Technical Service Bulletin: tsb100426

Intercooler Core Improvements

This Technical Service Bulletin informs the field of QSK60 and QSK78 intercooler core improvements. These improvements were implemented into production from the 27<sup>th</sup> of September 2005 for the QSK60 (Engine Serial Number 33161599), and from the 12<sup>th</sup> of September 2005 for the QSK78 (Engine Serial Number 66300659).

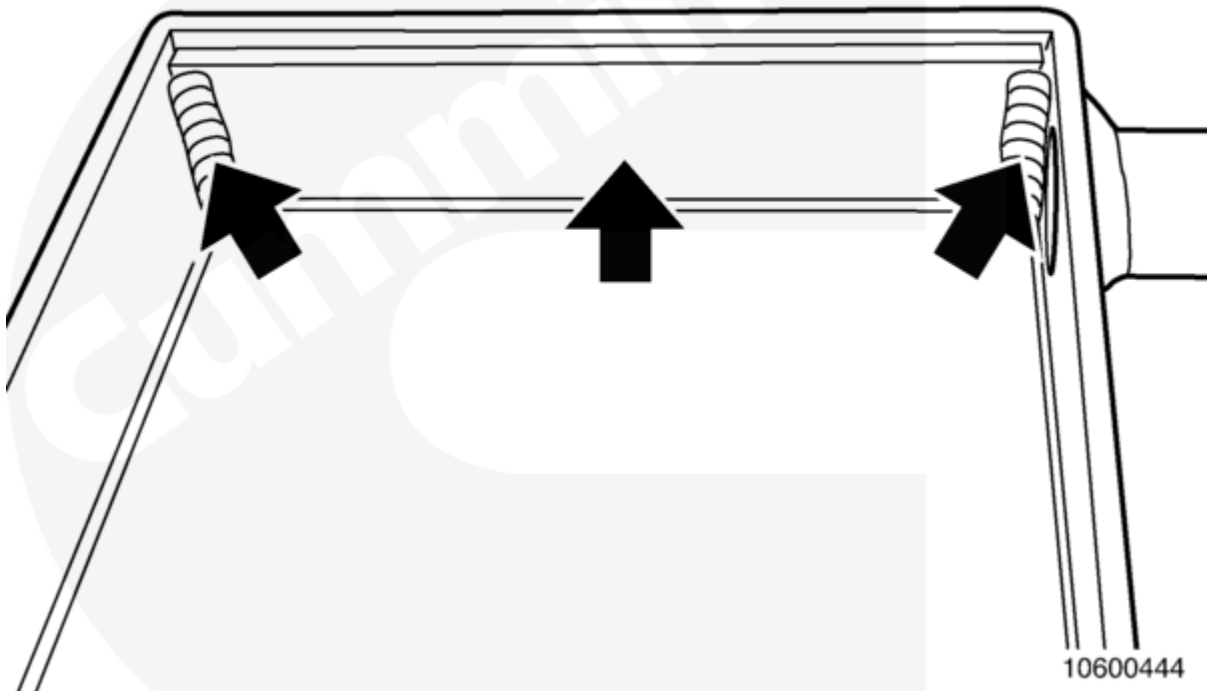
Improvements to the QSK60 and QSK78 intercooler core include improved flange thickness and extra welding, which have been added to improve the intercooler wall strength.

Section Through End of New Intercooler Core, Part Number 3637966

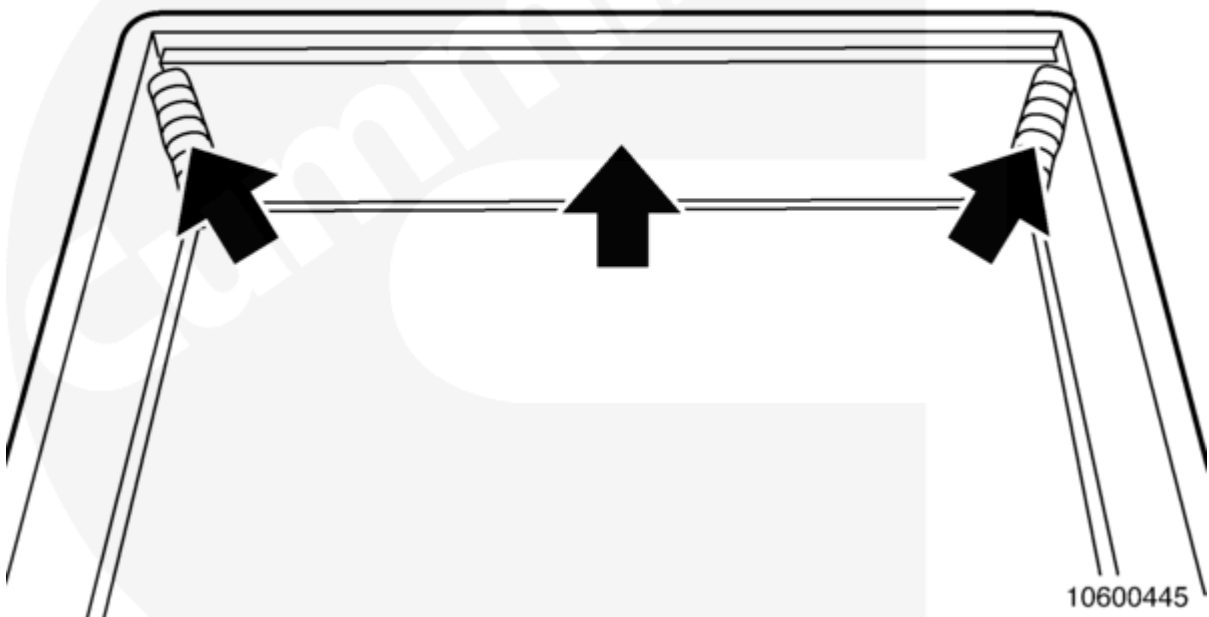
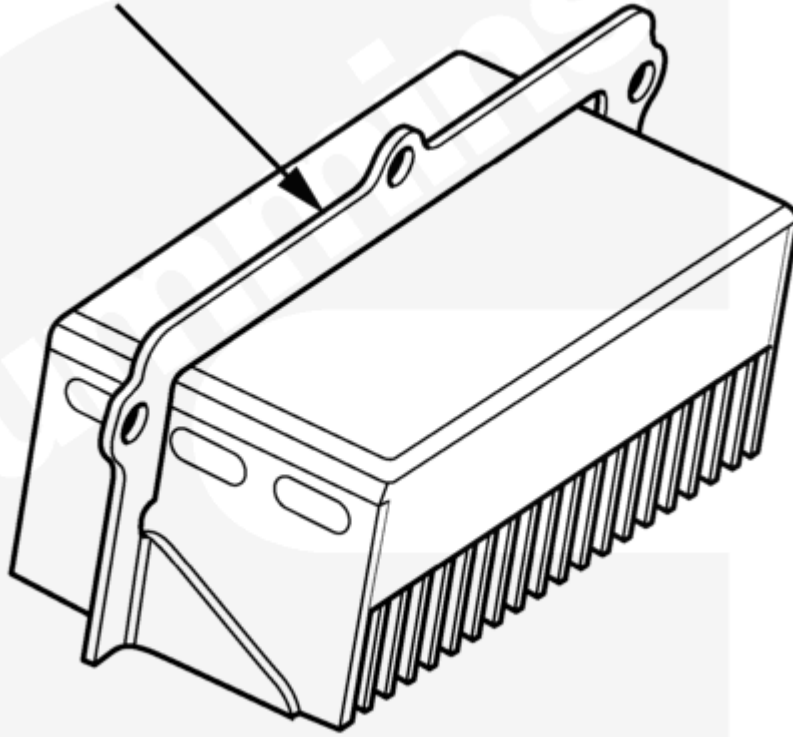
This has been achieved by adding stitch welds in the corners to secure the inner tank wall to the outer side plates, and thus creating better structural strength.

These modifications fix problems such as coolant leaks due to water pressure pulses opening the weld joint and flange cracks due to poor flange flatness.

Stitch Welds

Stitch Welds

Improved Flange Flatness

| Old Part Number | New Part Number |
|-----------------|-----------------|
| 3171310         | 3637966         |
